Re: Bus Connects Templeogue/Rathfarnham to City Centre Core Bus Corridor Scheme
Templeogue/Rathfarnham to City Centre

Bus Connects Submission to An Bord Pleanála in respect of the Templeogue/Rathfarnham to City Centre Core Bus Corridor

Bord Pleanála Case Reference: HA29N.316272

Written By Senator Mary Seery Kearney

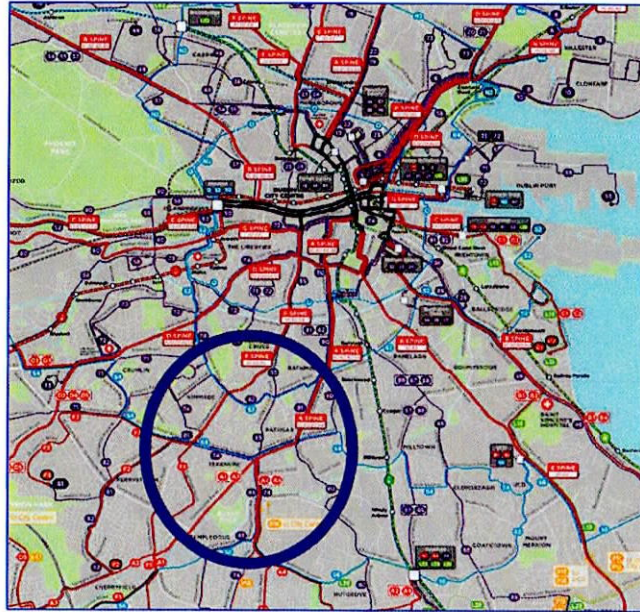
- Also of concern is the fact that considerable advertising monies are spent on ensuring that cars leave adequate room for cyclists when passing them out, and rightly so. This becomes a non-issue when you have continuous segregated cycling lanes and lends itself to the fact the urban traffic is going to travel in closer proximity to cyclists, hence the need for segregated cycling as a safe area for cyclists who are the more vulnerable road users. However, the width of cycling lanes as set out in the National Cycling Manual, should be 2 meters to accommodate the space for the cyclist themselves, wobble room, the space to the left of a cyclist that must accommodate gullies and drains and the space to the right of the cyclist that will come into

the proximity of other road users. This minimum of 2 meters is not reached throughout whole sections of the proposed cycle tracks. This means that cyclists are obliged to travel less than the recommended space on the road alongside traffic that can quite often be less than mindful of their needs. See figure above.

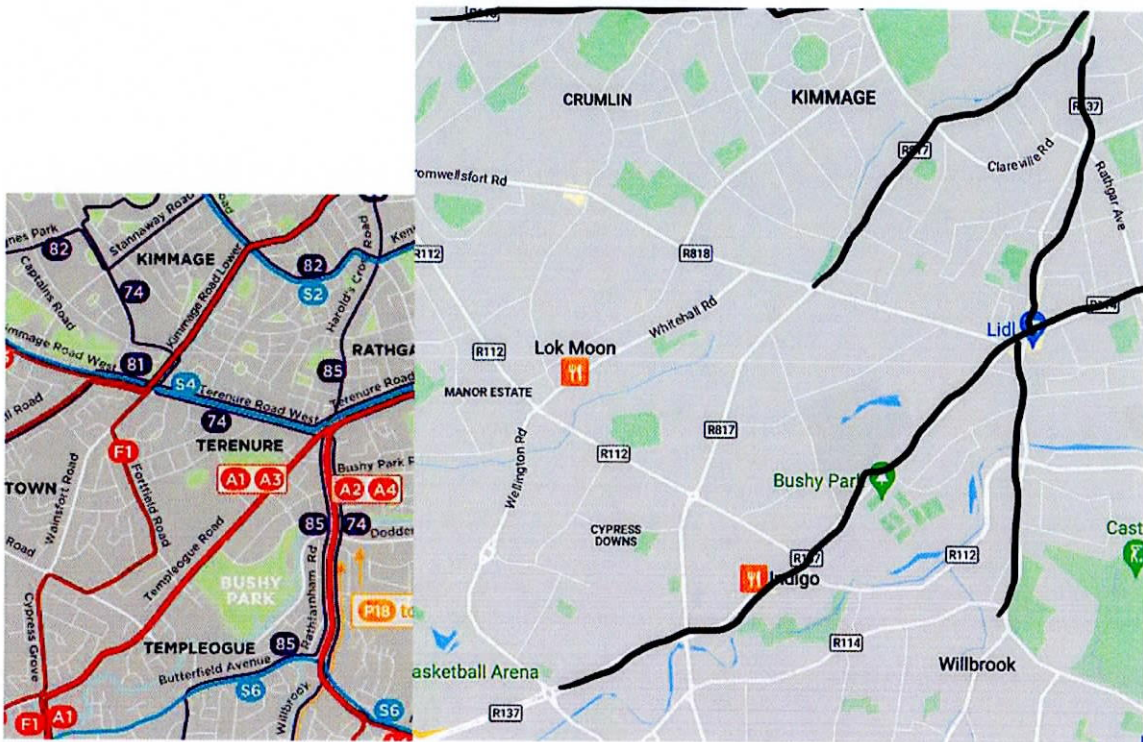
The map with the F1 bus route shown below on Cypress Grove Road and Fortfield Road, shows the only viable alternative for access to the city centre, hospitals, etc for that area and it will be accompanied by all of the traffic that is diverted from the Bus Corridor under consideration and it will be limited by the Kimmage Bus Corridor, where the red line for the F1 thickens. As the surrounding roads are either not accessible at all because of a bus gate, or barred from access due to the implementation of a ban on right hand turns, this route will be overpopulated with traffic, and yet this is a significantly increased bus route. This might be bearable if it were during rush hour/peak traffic times only, but it isn't – it's from 6am to 8pm every day of the week. The timing of the bus gate is nonsensical and an unnecessary diminution of the quality of life of the residents in that area. Residents will have to drive much longer routes to gain access and egress from their roads and to access hospitals, doctors, dentists, schools and shopping areas.

Meanwhile the 54A bus route as it was, proposed now as the F1, will be removed from its route along Templeville Road, a cause of much distress to elderly residents on Grosvenor Court off Templeville Road, who until now have ease of access to this bus route but under new plans will have to walk a considerable distance. This bus route will no longer travel the road outside Templeogue College, removing that direct connectivity up to a road running perpendicular to Templeville Road. Its route

along the section of Templeville Road it traverses, Fortfield Park where there are two schools St Pius X boys and St Pius X girls national schools, Fortfield Road where there is Terenure College as well as the drop off for Our Lady's School on Templeogue Road and now no right hand turns into Greenlea Road or Lavarna Grove, will be clogged with the traffic that would have otherwise been able to travel along Templeogue Road. The traffic surveys carried out show that up to 7,404 vehicles that currently use Templeogue Road 300 of which is lorries, will be prohibited from so doing due to the bus gate. 1,440 vehicles will remain on Fortfield Road as they will be prohibited from going down Greenlea Road – that is how many vehicles will be trying to turn right towards the KCR now and causing that backlog of traffic. That is a considerable displacement from those two roads alone that will now be using the route alongside the F1 bus route. This alone demonstrates that the objective as set out will not be achieved for this section of road.
